### **AMENDMENTS TO THE DRAWINGS**

## **REMARKS**

Fig. 5

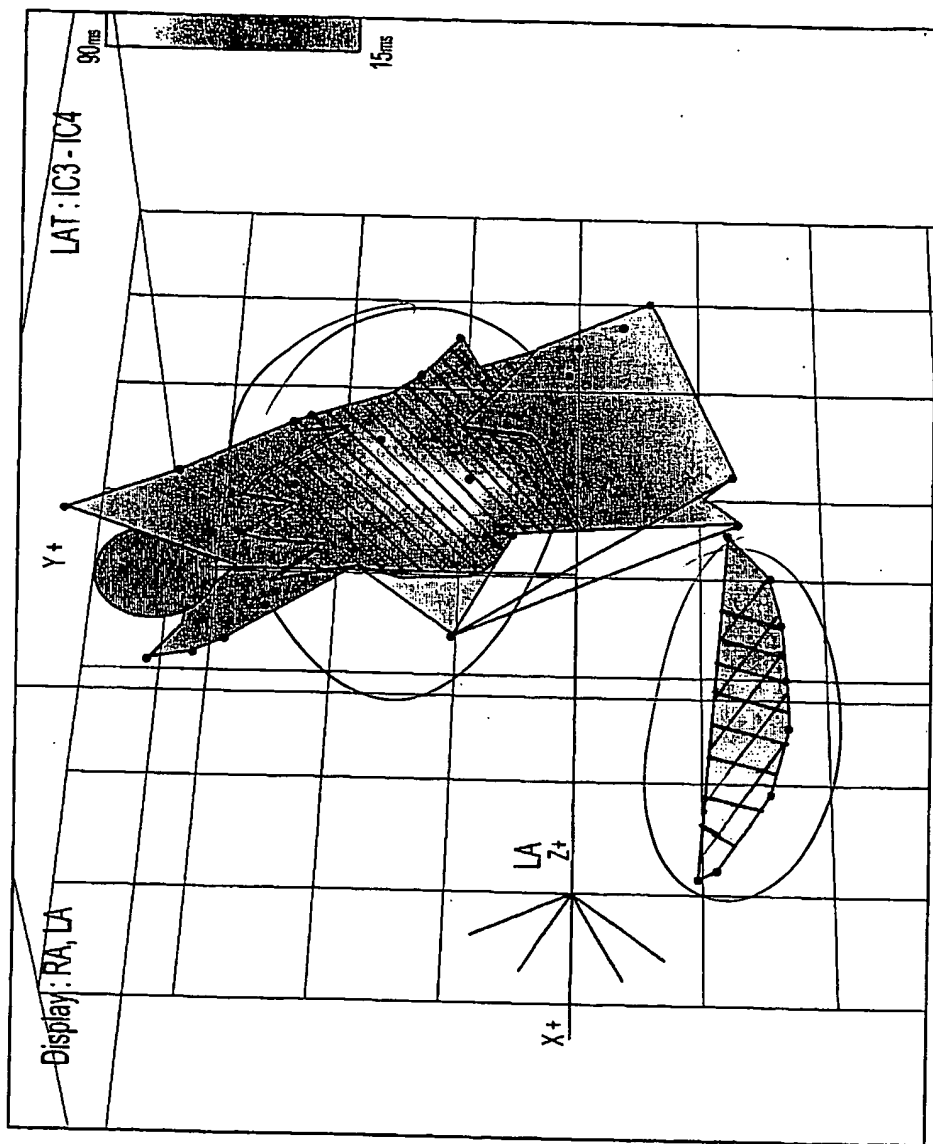
The attached two sheets of drawings include changes to Figs. 3A-3B and Fig. 5. These sheets replace the original sheets including only Figs. 3A-3B and Fig. 5, respectively. In Figs. 3A-3B, the vertical reference lines have been added back in since they were on the original figures and inadvertently left out on the formal drawings. In Fig. 5, the "square-marked" area and the "hatched" area, referred to in paragraph [0037] of the specification, have been clarified since the previously submitted black and white copy of Fig. 5 did not clearly indicate these areas. No new matter has been added.

Figs. 3A-3B and Fig. 5 have been amended herein to clarify certain aspects of the drawings and to correct minor problems with the drawings as described above herein. No new matter has been added. Applicant respectfully requests that the amended Figures be entered.
